MEMO TO: Prospective Bidders
FROM: Kimberly Toon, Purchasing Manager
SUBJECT: **Addendum #1:** ITB – Mazarick Park Tennis Center Tennis Sitework
DUE DATE AND TIME: **October 31, 2024; 2:00 p.m.**

1. The Bid Documents are hereby modified per the attached Addendum #1 dated October 28, 2024. To include the following:

**Mazarick Park
 Tennis Center**
 730 Filter Plant Road
 Fayetteville, North Carolina

sheet **C100**

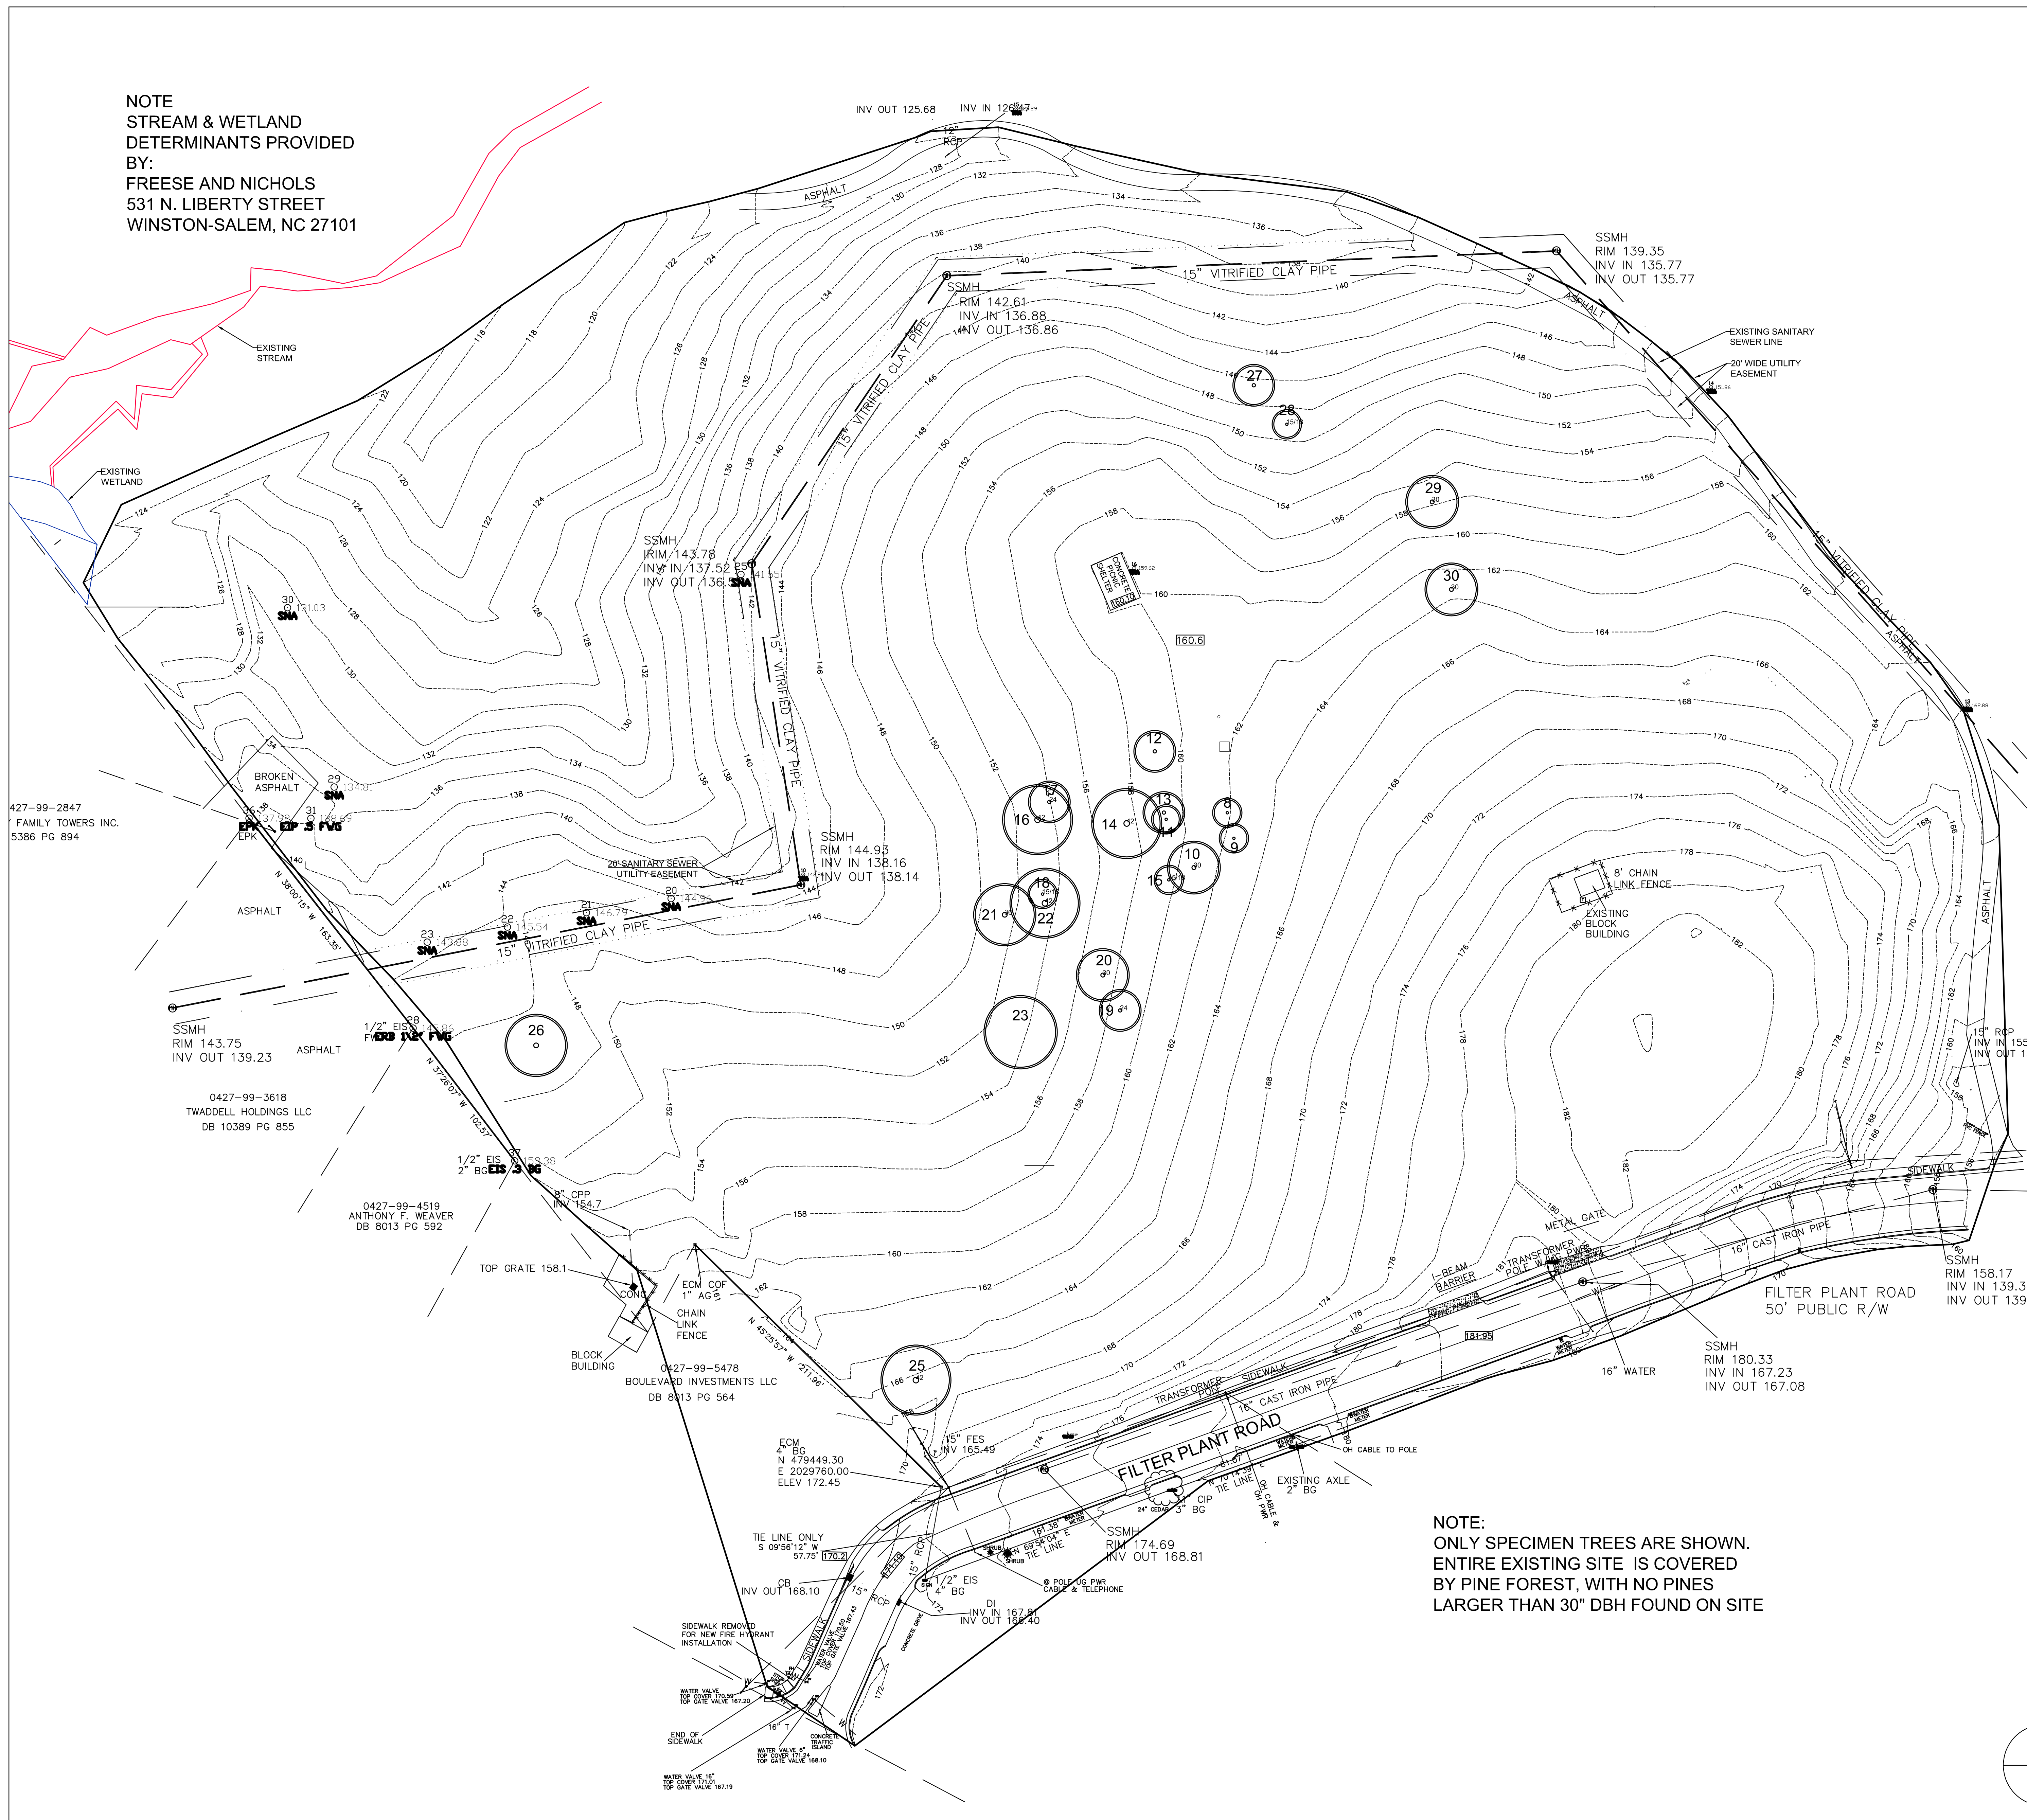
Question: Is the surveyor information available from the original project?

Answer: Yes. The original survey is attached to addendum 1 as sheet C1.0.
